Source	Comments Made	Response									
Thurston Parish / Others	Concerns that this staggered junction [at Fishwick Corner] will result in any vehicles leaving the village to access the A14 for BSE/Cambridge having to turn left and then wait in the middle of Mount Road to turn right. On-coming traffic on Mount Road will be approaching around a blind bend where accidents regularly occur.	<p>The number of vehicles making these turning manoeuvres (2024 + Committed + Dev) is identified below.</p>  <p>The assigned traffic flows are based on the traffic survey of the junction and include the committed development traffic, the Bloor Homes development, the Gladman development and background traffic growth. The following movements turn out of and cross the junction.</p>

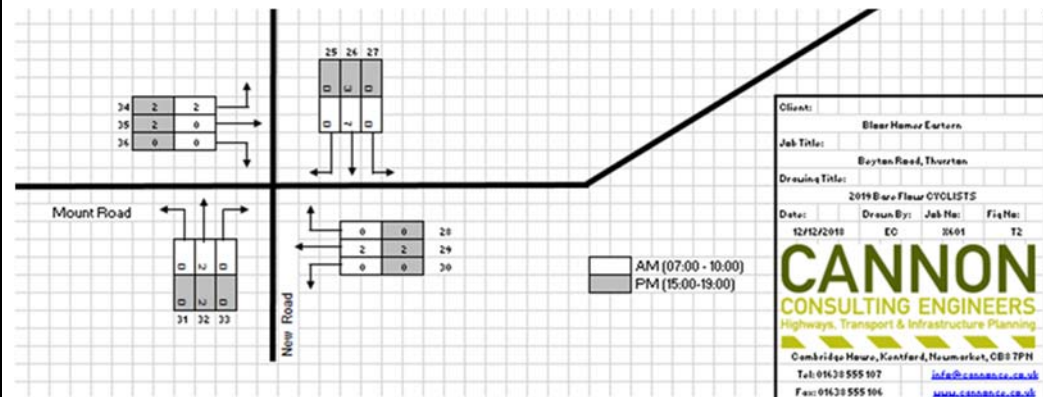
Thurston Parish / Others	The majority of transport improvements proposed at main junctions are likely to compromise the safety of cyclists.	The proposals offers safety improvements for all road users, including cyclists. This is through a combination of improved inter-visibility between road users including any cyclists at the junctions. Road space would still need to be shared between vehicles and cyclists as it is currently throughout most of Thurston. As such, the improvements at these junctions are of benefit to cyclists and we do not consider that their safety is further compromised.

The number of cyclists using the Fishwick Corner junction recorded in the 2019 base surveys is very low. Some 11 cyclists were recorded at the junction during the morning three hour period 07:00-10:00 and 11 cyclists were recorded at the junction during the evening four hour period 15:00-19:00.

The speed limit in the vicinity of the cross roads has recently been reduced to 40mph. This will further improve the safety of the local roads for cycling.

Consideration has been given to the area of redundant highway and whether this could be used as a safe crossing point for cyclists. A scheme can be delivered to achieve this within highway land that would otherwise be redundant.
